Overview: Production error in version 1.0 harnesses; The immobilizer wire (orange/black) is in pin position #4 instead of pin position #5. Although an effort to correct the issue was made, some quantity of harnesses did get shipped before the issue was spotted. We are advising to inspect the harness BLADE connector before attempting to install harness or program the module. This issue is not known to affect the version 2 harnesses, which require no modification.

Overview: Early versions of the FTI-STP1 harness require modification for **automatic transmission (AT)** applications, some of the product was able to be modified before release, but a small quantity was released without modification.

FTI-STP1: Vehicle Coverage and Preparation Notes

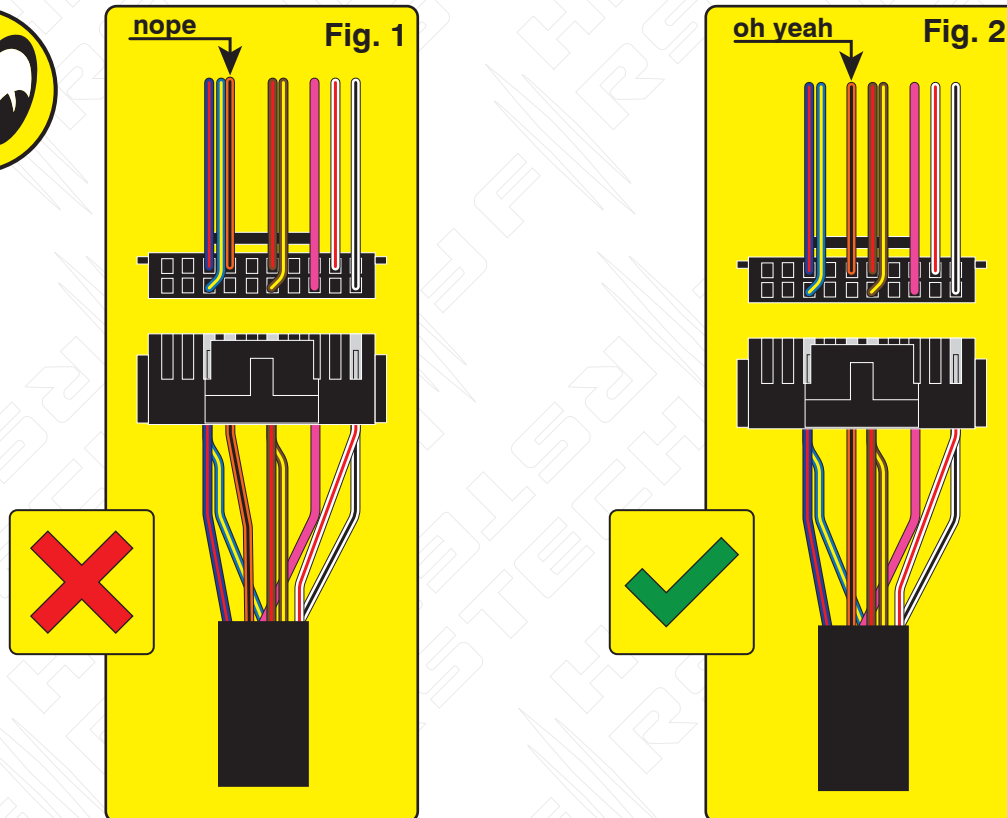
Issue: Module fails to program correctly to vehicle, does not allow the vehicle to be remote started.

Correction: Step 1.) Locate the orange/black wire and confirm whether it is positioned as illustrated in Fig. 1 or Fig. 2. If the wire is as illustrated in Fig.1, proceed with Step 2 through 5 and complete the repair procedure outlined, if the wire is as illustrated in Fig. 2, correction is not necessary, proceed with harness installation and module programming.

Step 2.) Using a pick, lightly depress the catch that secures the terminal in the housing then remove the wire and terminal from the housing.

Step 3.) Using a fine tip razor or utility knife, insert the blade beneath the terminal catch and raise it slightly, so that it can be reused to secure the terminal when reinserted into the BLADE connector housing.

Step 4.) Refer to Fig. 2 for correct position of the orange/black wire (next to brown/red) then reinsert the terminal, pressing lightly until the catch 'snaps' into place, securing the terminal in the connector housing.

Step 5.) The repair is complete, proceed with installation and programming.

MODIFICATION REQUIRED FOR A/T APPLICATIONS, ONLY WITH v 1.0 HARNESS

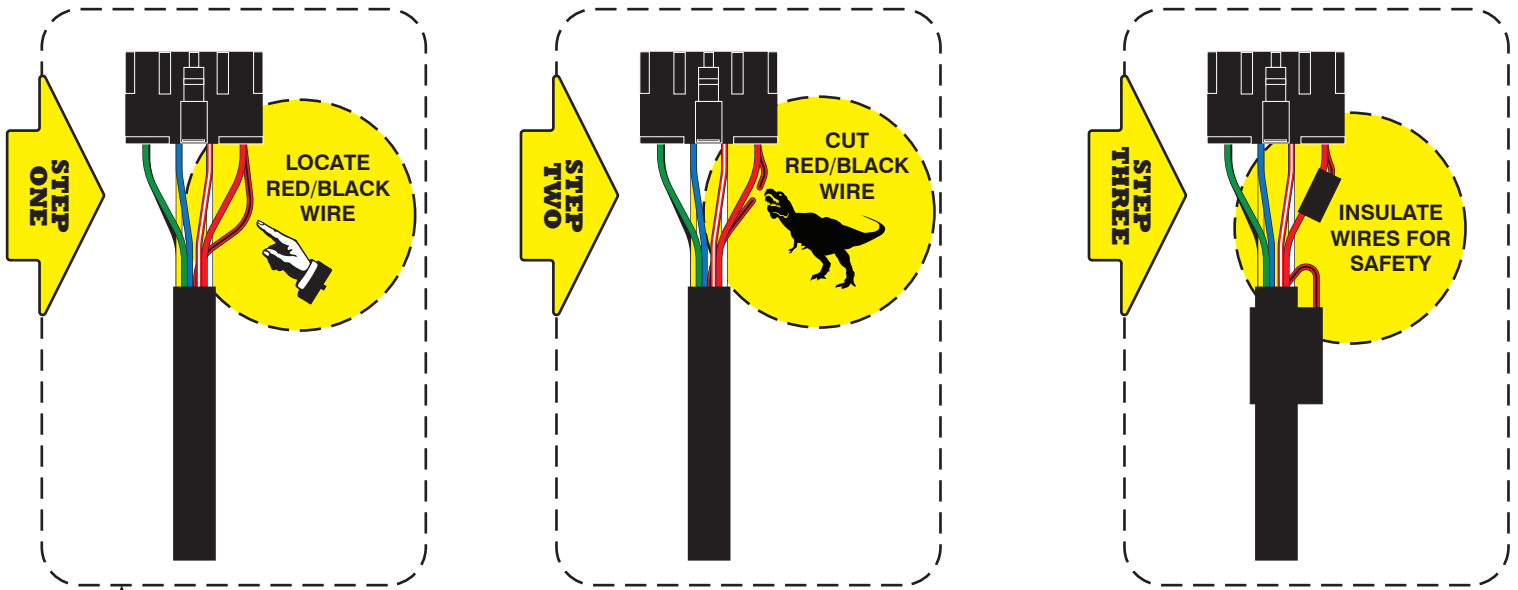
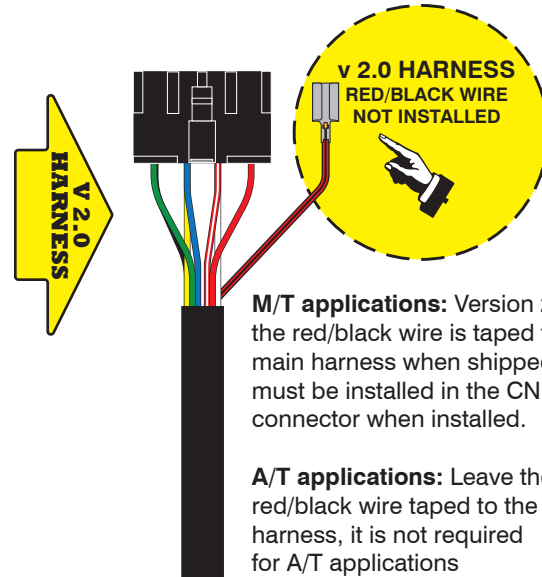
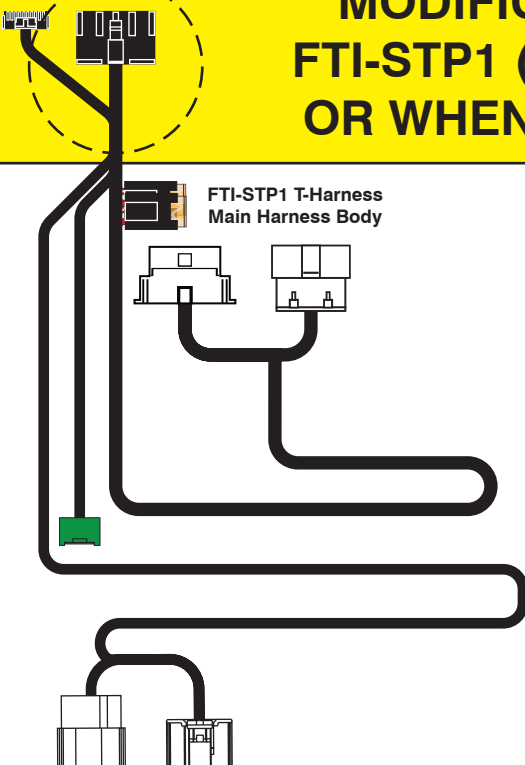
Issue: The FTI-STP1 T-harness has been designed to be compatible with A/T (automatic transmission) & M/T (manual transmission) applications, but due to an oversight in early production runs, the selection was defaulted to M/T mode.

Using a harness configured for an M/T application, in an A/T equipped vehicle, could result in vehicle module damage, it is advised that the harness be returned to A/T mode before installation in vehicles equipped with an automatic transmission.

Correction: Locate the **red/black (+ Clutch)** wire provided in the CN1 connector of the main harness assembly. Cut the **red/black** wire, either flush to the CN1 connector, or leaving enough wire exposed so that you can insulate and secure the ends of the wire that remain after cutting. Insulate each of the remaining ends of the **red/black** wire and secure to prevent any possibility of a short circuit. **If the red/black wire has already been disconnected, no further modification is required for A/T applications**
